TP2 ADDENDUM # (4) Four

Project:	**Drayton Valley Brazeau Aquatic Centre**
Tender Package:	**TP2**
Issued By:	**Harry Hanson**
Date Issued:	**May 27, 2021**
Tender Closing:	**June 2, 2021**

Architectural Addendum No. 02
Drayton Valley Aquatic Centre

May 26, 2021
File No. 19046

10 | STUD WALL OR CONCRETE BLOCK WALL AT OWSJ OR BEAMS
SCALE: 1 : 5

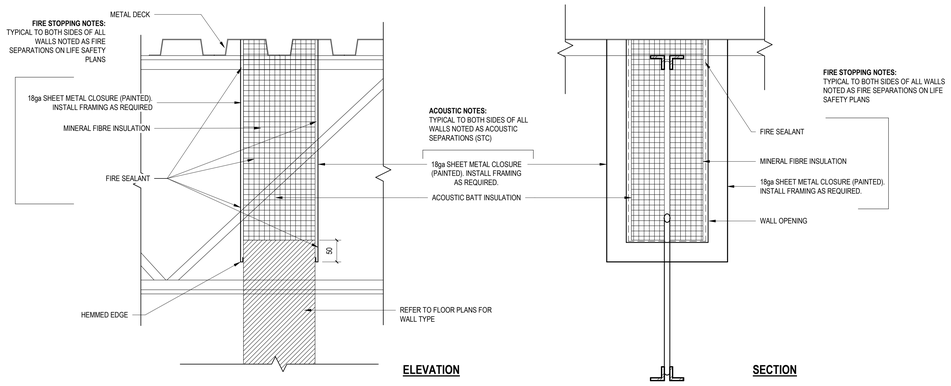
.1 **ADDED**: DETAIL #10 – STUD WALL OR CONCRETE BLOCK WALL AT OWSJ OR BEAMS

1 | MAIN FLOOR REFLECTED CEILING PLAN
SCALE: 1 : 100

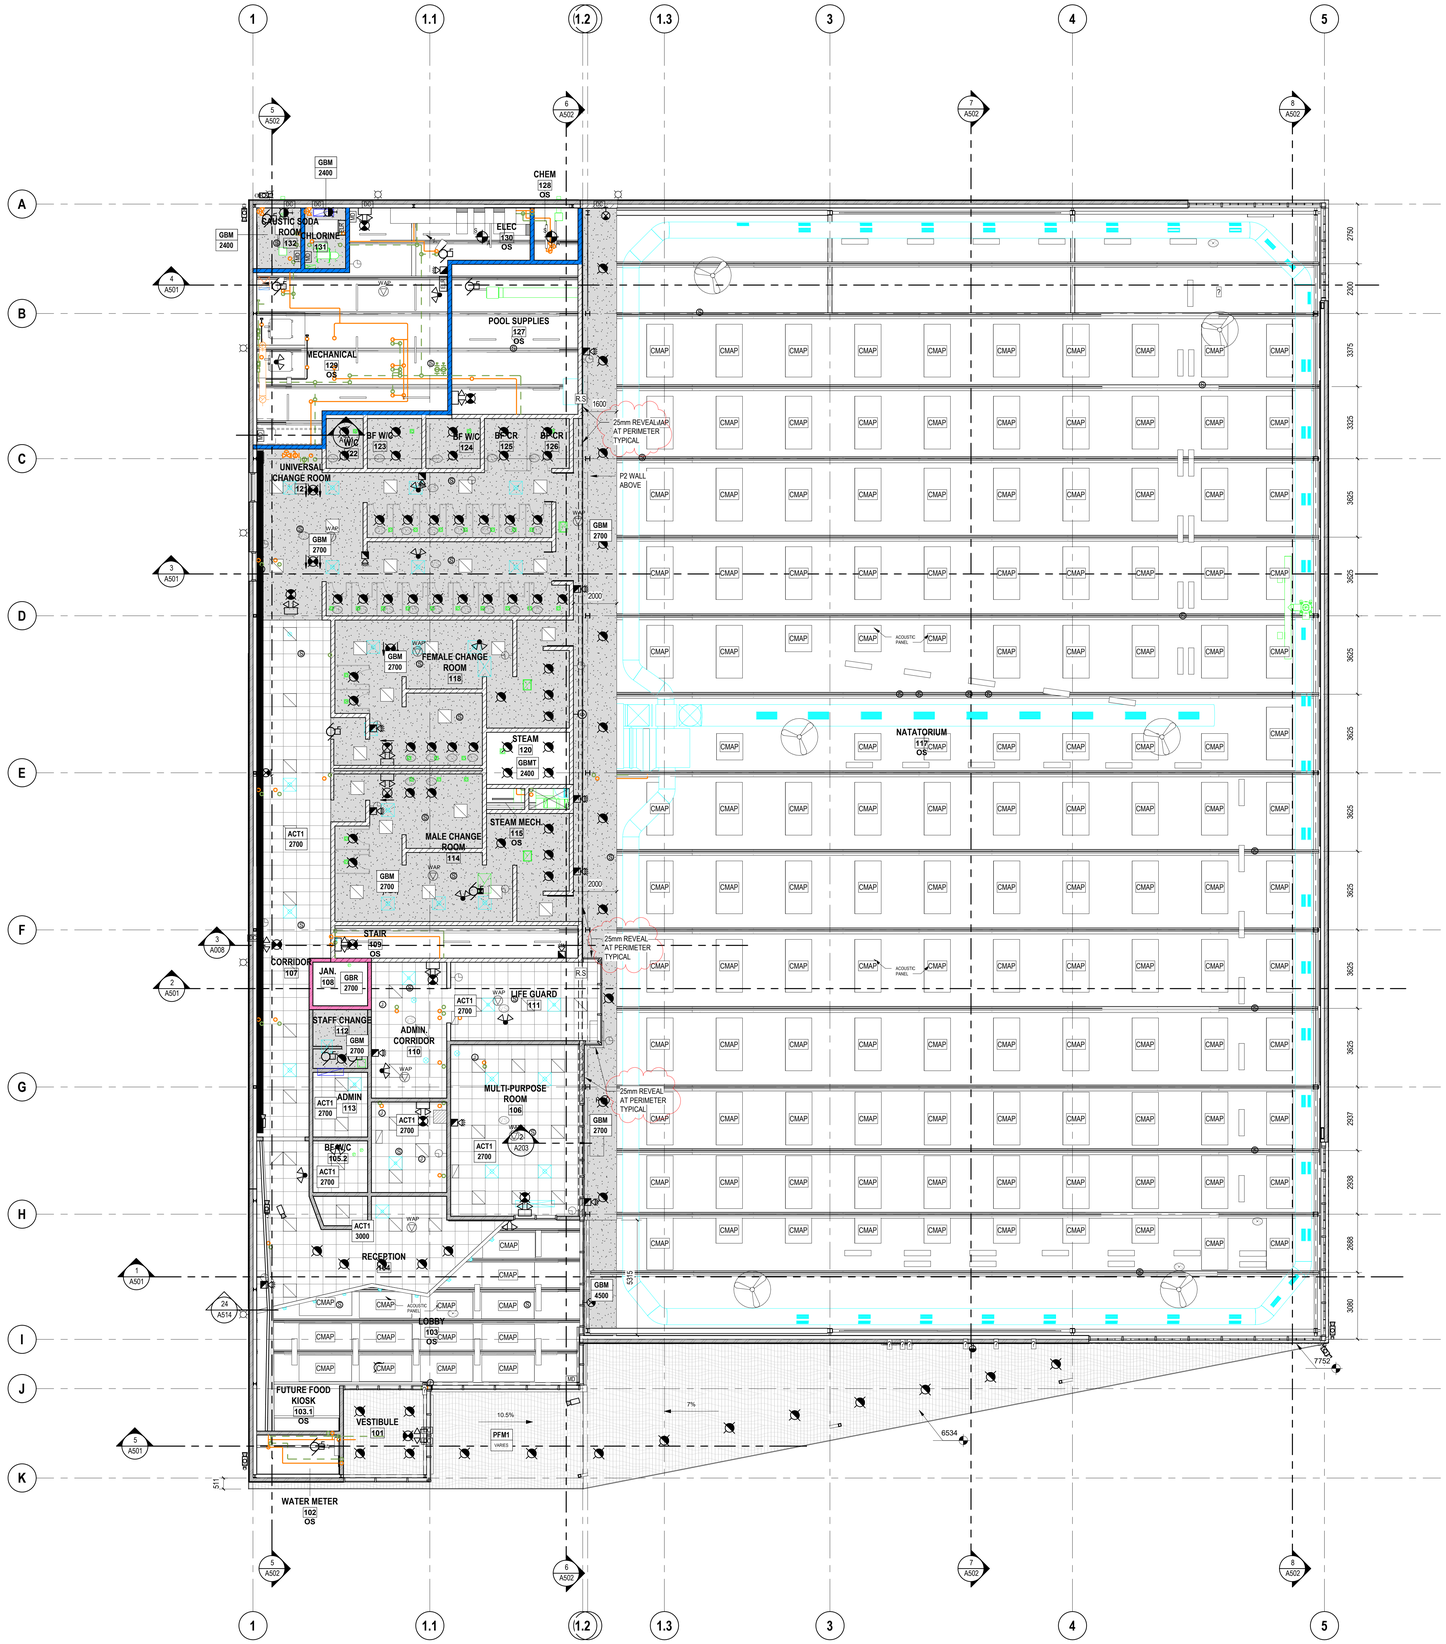
.1 **ADDED**: 25mm REVEAL ALONG BULKHEAD – GRID 2

6 | SECTION GRID 2
SCALE: 1 : 100

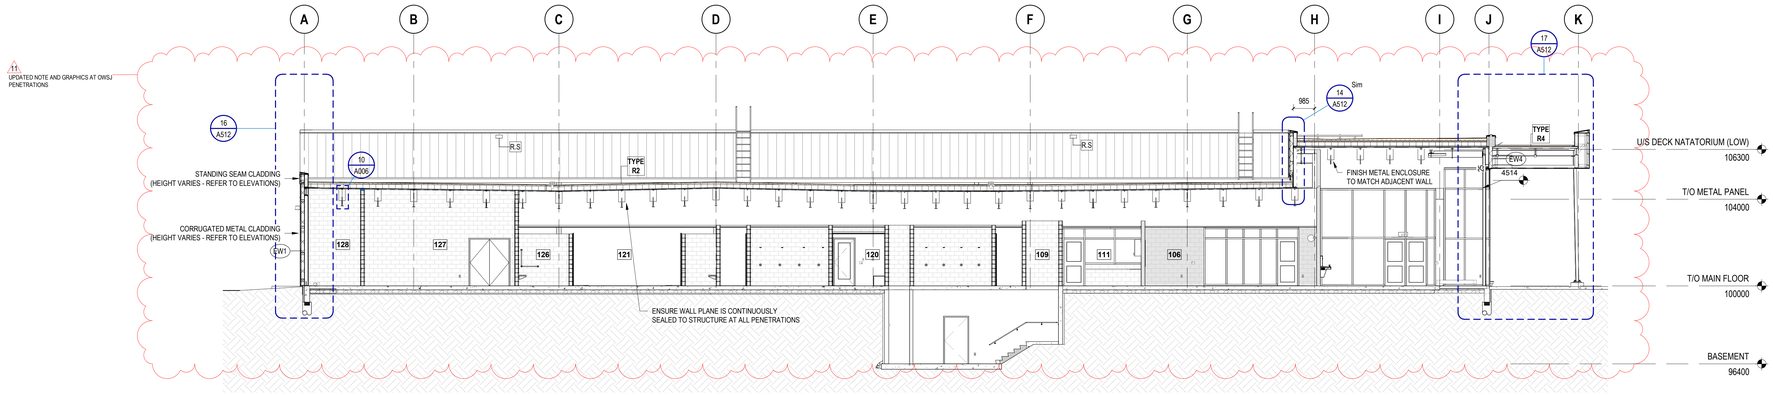
.1 **REVISED**: SECTION GRID 2

CHECKED	DRAWN	DRAWING	REVISION
TS/SF	JN	A510	11

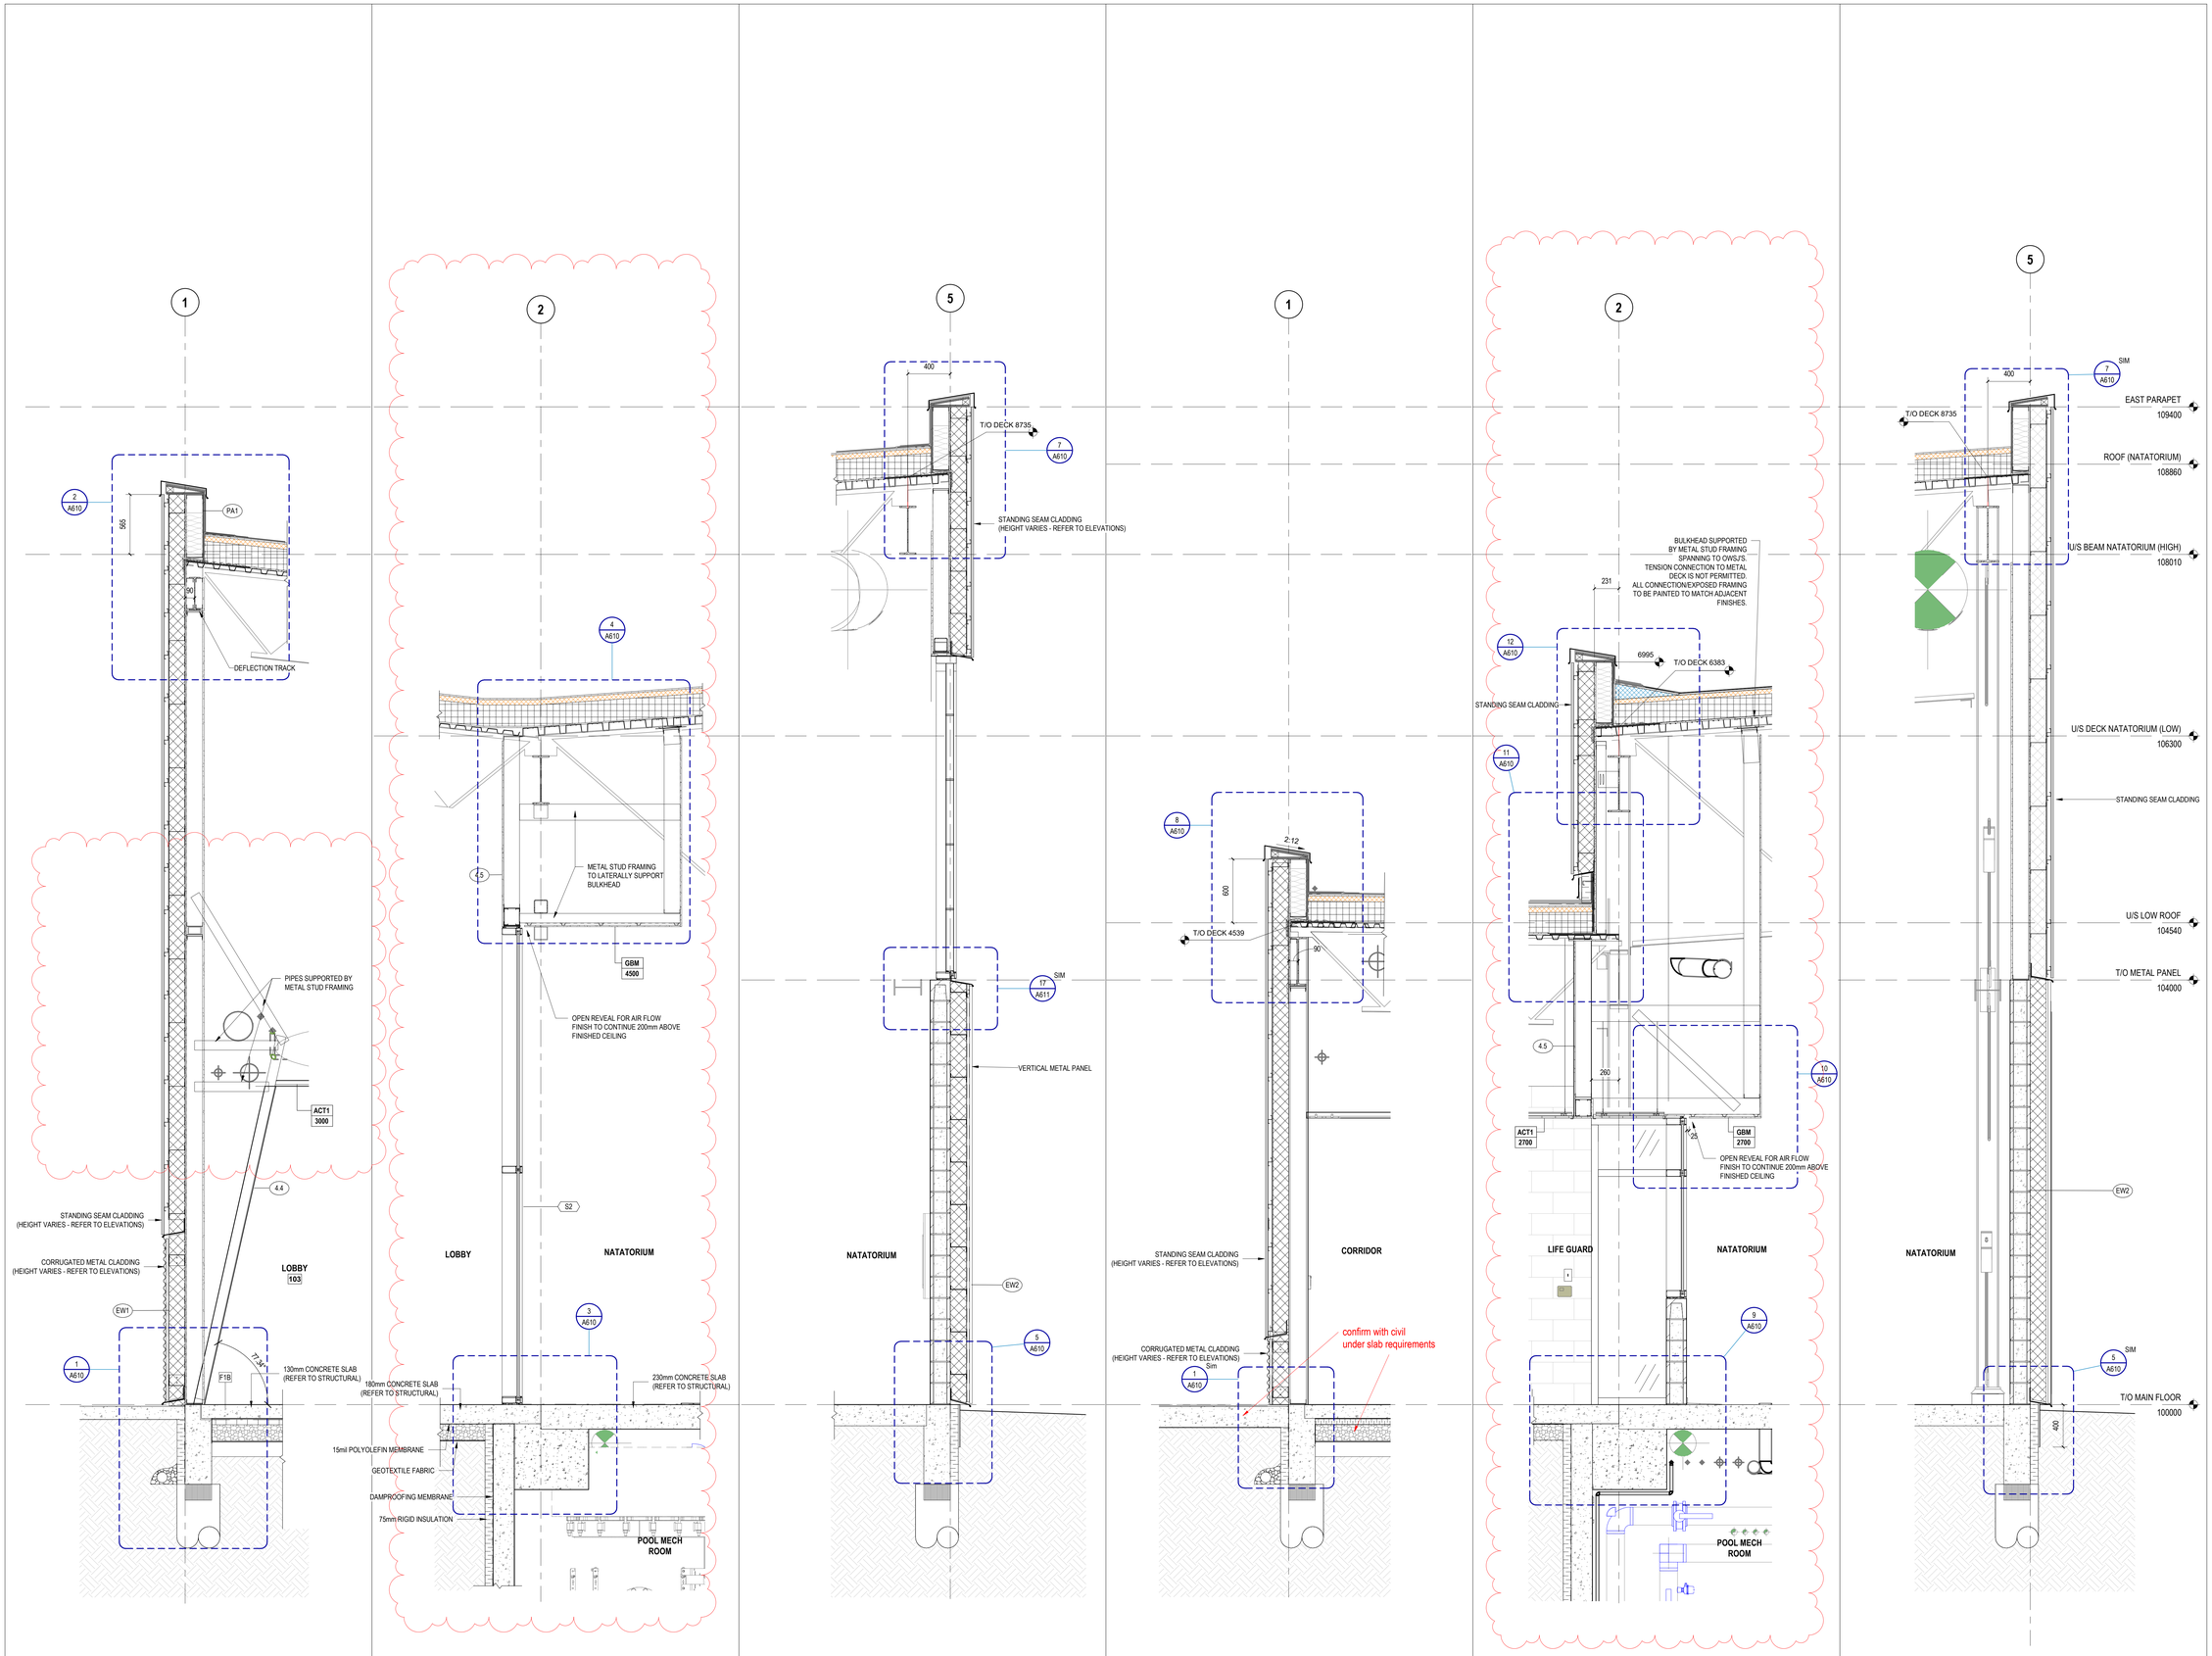
.1 **CLARIFICATION**: DETAILS #1,2 AND 5 - FRAMING UPDATES

8 | GRIDS C-D AT GRID 2
SCALE: 1 : 20

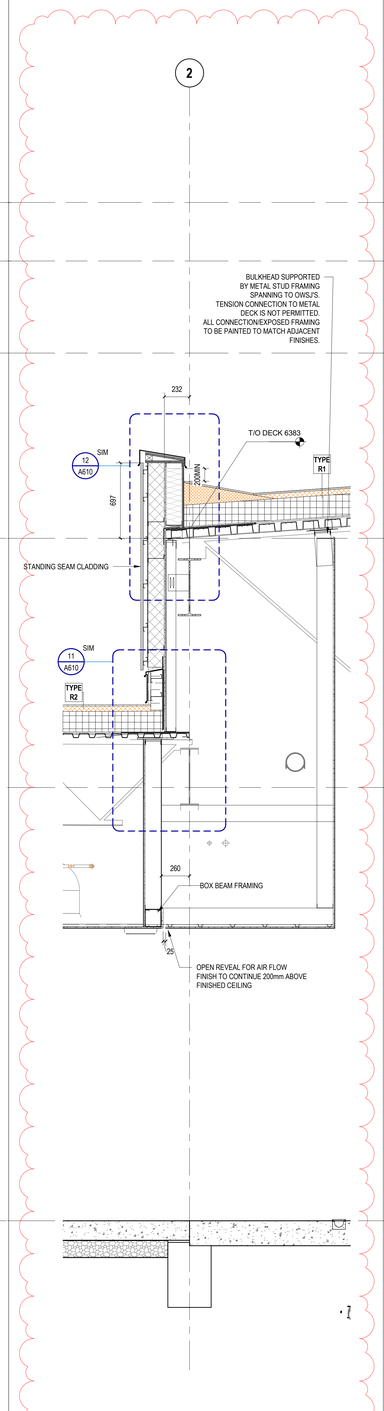
.1 **CLARIFICATION**: DETAILS #8 AND 11 - FRAMING UPDATES

CHECKED	DRAWN	DRAWING	REVISION
TS/SF	JN	A512	11

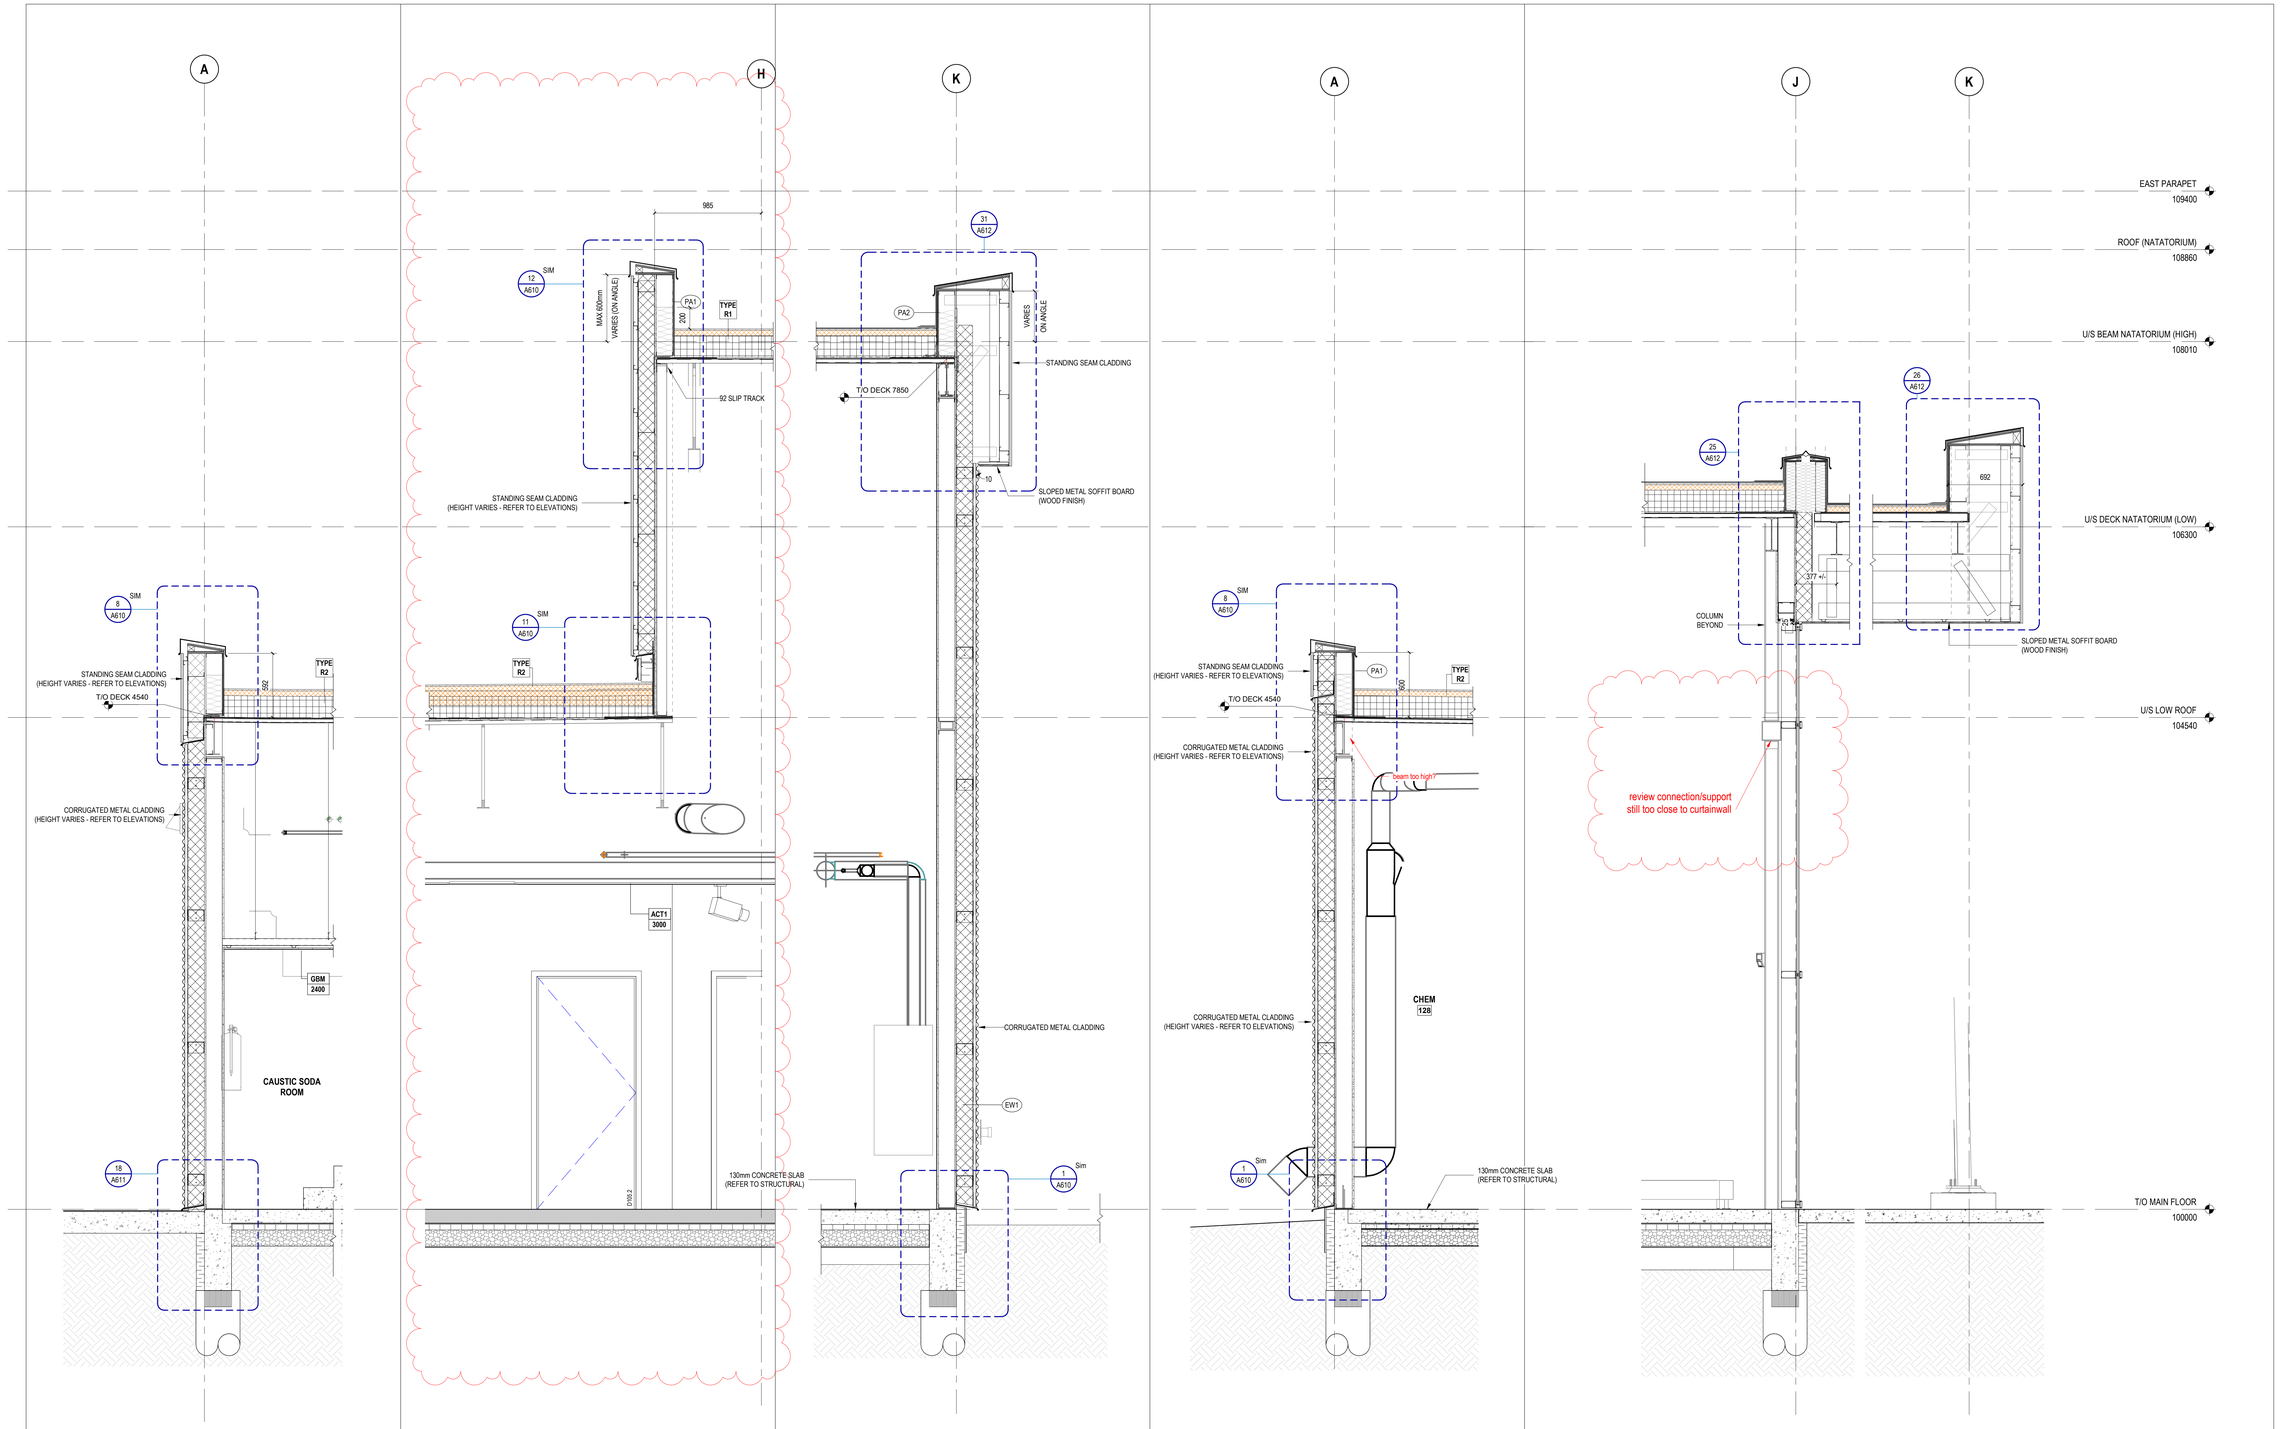
.1 **CLARIFICATION**: DETAILS #14 AND 17 - FRAMING UPDATES
